Golder Associates Ltd.

November 27, 2007

**RE: LANDFILL DESIGN AND MANAGEMENT PLAN
SUPPLEMENTARY INFORMATION
MEADOWBANK GOLD PROJECT, NUNAVUT**

PROJECT	AGNICO-EAGLE MINES LIMITED MEADOWBANK DIVISION
TITLE	LANDFILL DETAILED DESIGN LANDFILL #1 CROSS SECTIONS
PROJECT No. 06-1413-089	FILE No. 061413089-1400-FIG_1
DESIGN BW 15AUG07	SCALE AS SHOWN REV. -
CADD AS 15AUG07	
CHECK	
REVIEW	
Golder Associates	DWG 3

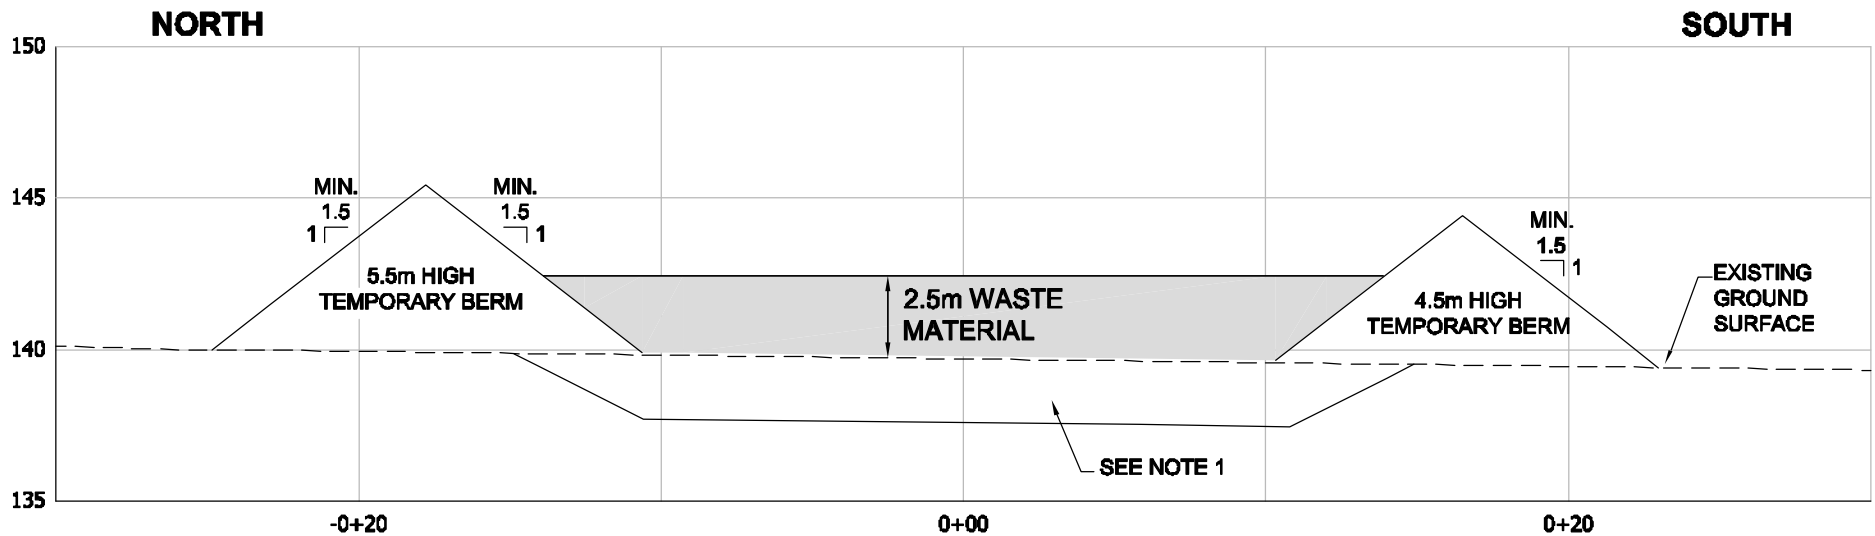
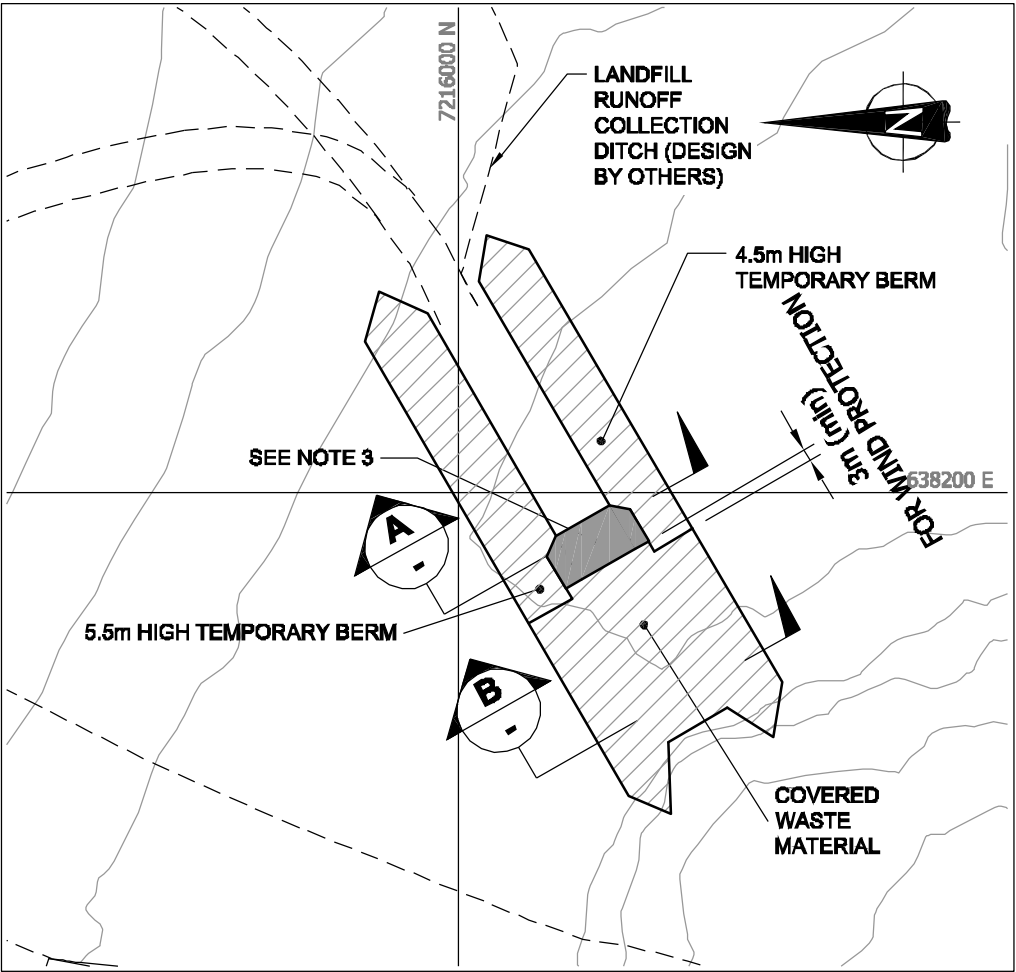
- The 'Landfill report' states explicitly under **Section 4.1 - Approach** that: *'the leachate from the proposed landfills is anticipated to be very weak due to the controls on materials placed in the landfill and thus site specific landfill leachate management is not considered to be required.'* As ash from the incinerator is proposed to be disposed of in the landfill, INAC recommends leachate monitoring. [INAC]

The design of Landfill #1 does not require imported materials or exacting survey data or measurement. This is due to the restriction on materials that can be landfilled as described in Golder's August 2007 report and the location of the landfill within the catchment of the Portage RSF. These factors reduce the need for leachate collection or control or mitigation measures against vectors such as carnivores or raptors. Thus, the main environmental mitigation measure required is a wind screen to reduce wind blown debris. Wind protection for the waste is provided by the 5.5 m high north perimeter berm and the 4.5 m high south perimeter berm and the progressive closure of the landfill facility as indicated on Note 3 and Cross-Section A of Drawing 3.
